REMARKS

This application has been carefully reviewed in view of the Office action mailed April 17, 2002. Claims 1, 2, 8, 10, 17, 19-21, 26 and 29-31 have been amended. Claim 32 has been cancelled. Figures 2, 3 and 4 have been amended. Furthermore, paragraphs on pages 1, 8 and 9 of the Specification have been amended. Reconsideration and favorable action in this application is respectfully requested.

FIG. 2

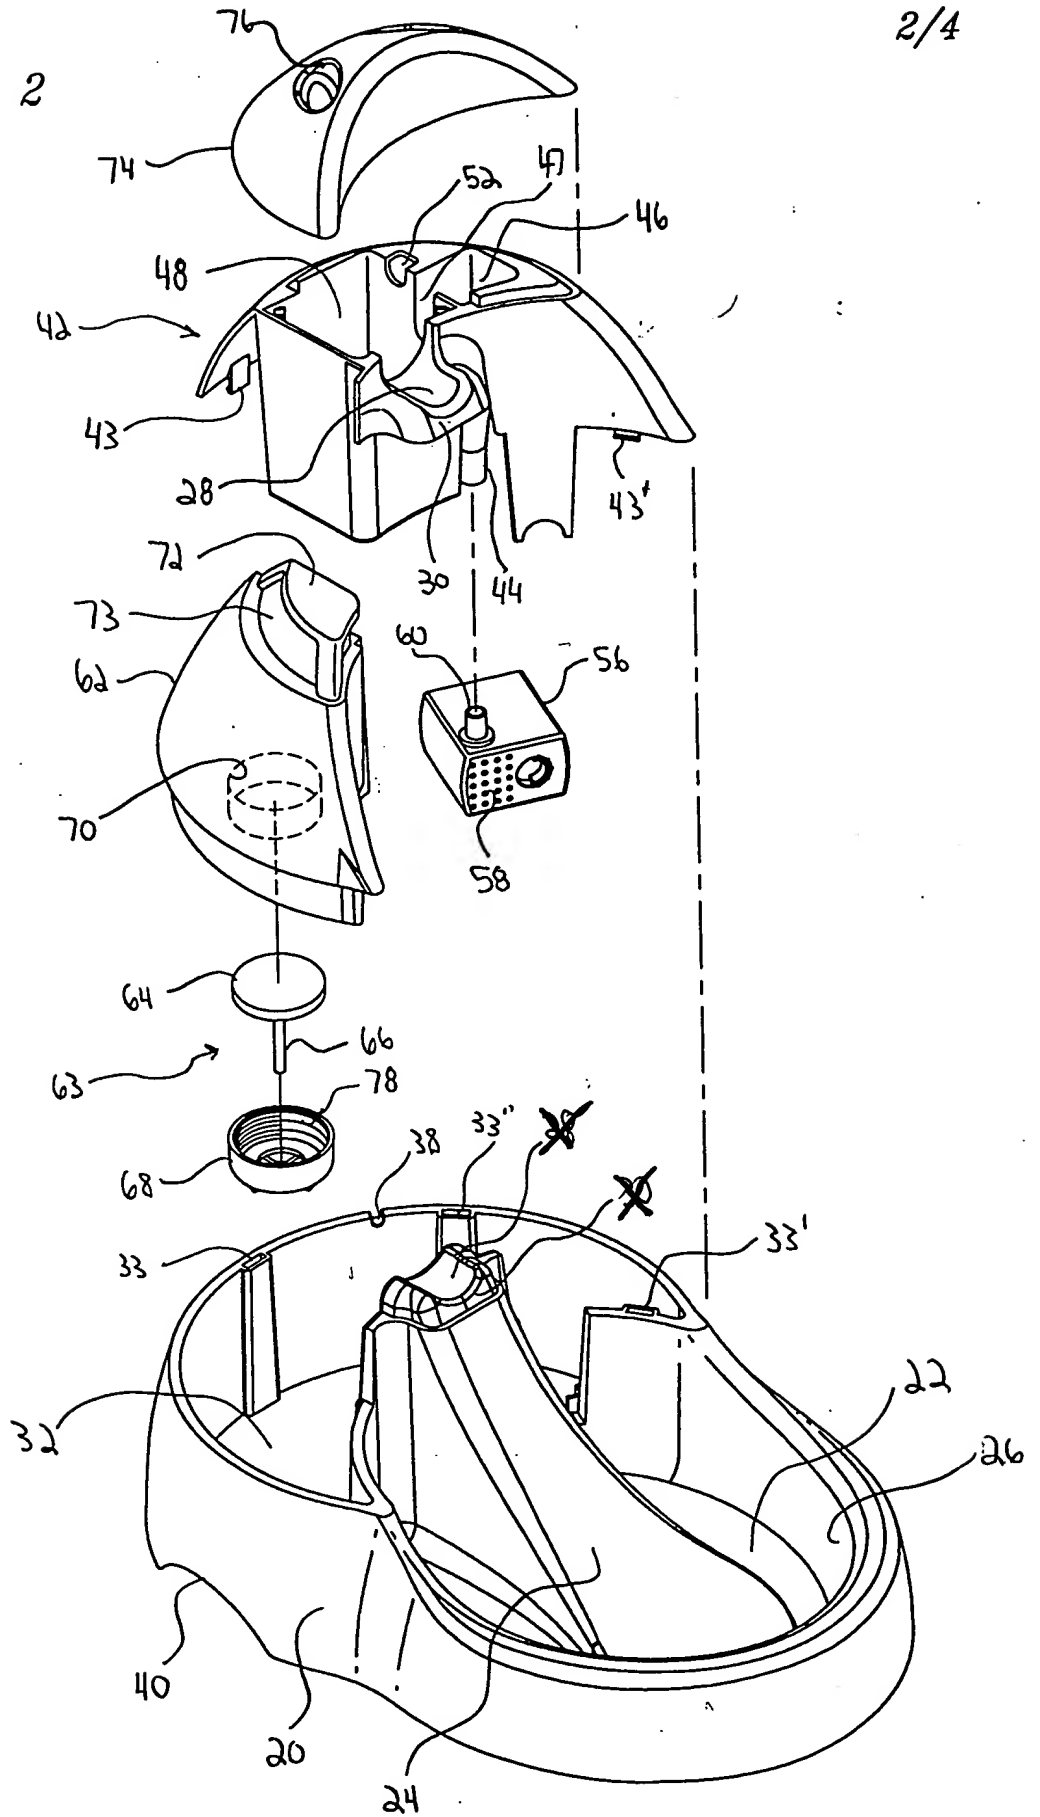
The Examiner has objected to the drawings as failing to comply with 37 CFR 1.84(p)(4) because reference characters "28" and "30" have been used to designate parts on both items 20 and 42. Applicant has corrected the drawings by deleting reference characters 28 and 30 on item 20. A marked up copy of Figures 2, 3 and 4 is attached hereto together with a clean copy of Figures 2, 3 and 4. Examiner approval of these drawing corrections is respectfully requested.

FIG. 4

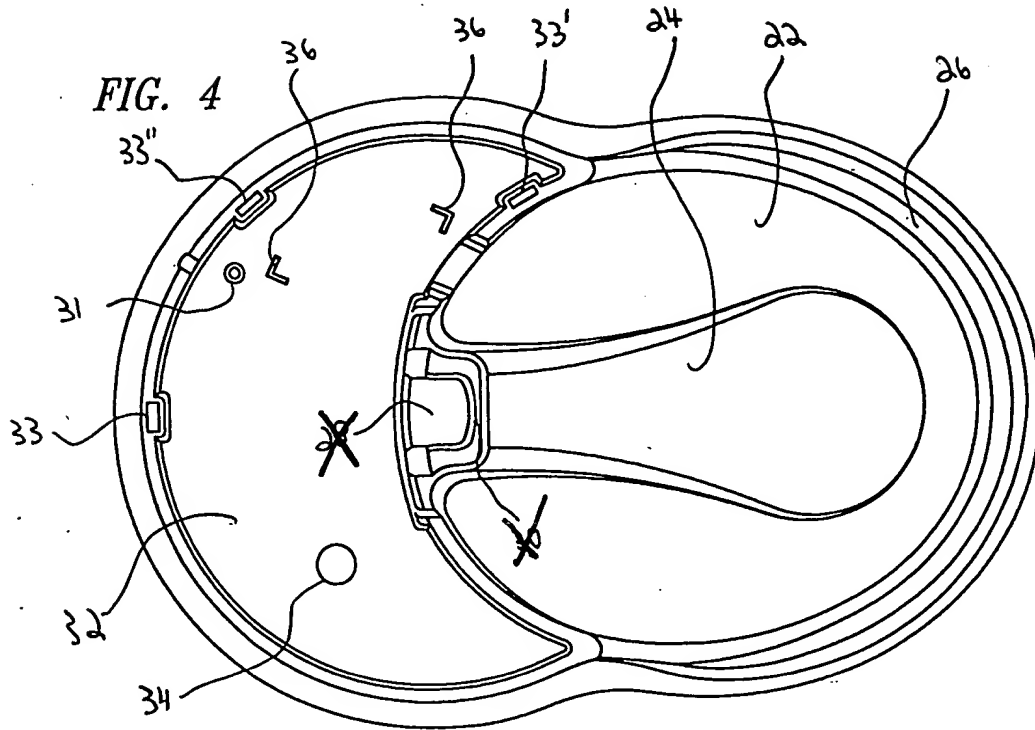
Once reservoir 62 is filled, it is placed above rear container 32 and adjacent water processing apparatus 42. Cover 64 and stem 66, which extends downward from reservoir 62, are pushed upward by bump 34 (FIG. 4) to allow water to flow through opening 86. When the water level in lower container 20 falls below a minimum level from use or by evaporation, water will be gravity fed into container 20 to replenish the water supply. This configuration provides substantially silent operation as pump 56 is submerged at all times during operation, regardless of whether or not water is delivered to the lower container in a non-splashing manner. After reservoir 62 empties, the owner can remove the reservoir from waterer 18 using grips 73, to detach valve assembly 63 and re-fill the device for continued use. Reservoir 62 comprises a flat storage surface 72 to allow owners to place it on flat surfaces when filling or storing the device.
